**Beacon Solar, LLC
700 Universe Blvd.
Juno Beach, FL 33408**

Subject: Questions from Rancho Seco Residents

**BEACON SOLAR ENERGY PROJECT (08-AFC-02)
RESPONSES TO RANCHO SECO QUESTIONS**

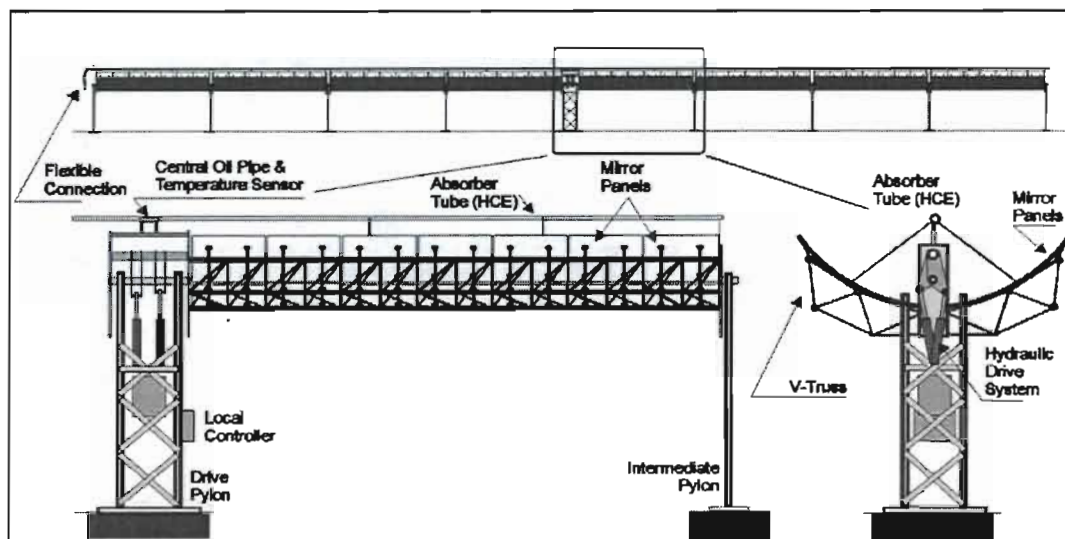
How big are the solar panels and how much water does it take to wash each panel?

The solar panels, typically referred to as Solar Collector Assemblies, that have been proposed for the project are 492 feet long and 19 feet wide. The height of the mirror will vary between 17 – 22 feet depending on the time of day. A diagram of a similar assembly used at the existing SEGS plants is shown below. Based on previous experience the amount of water required to mirror wash is 0.23 gallons per square meter of mirror. To wash one solar collector assembly would require approximately 190 gallons of water. The assemblies will be washed based on soil loading, averaging about once every two weeks.
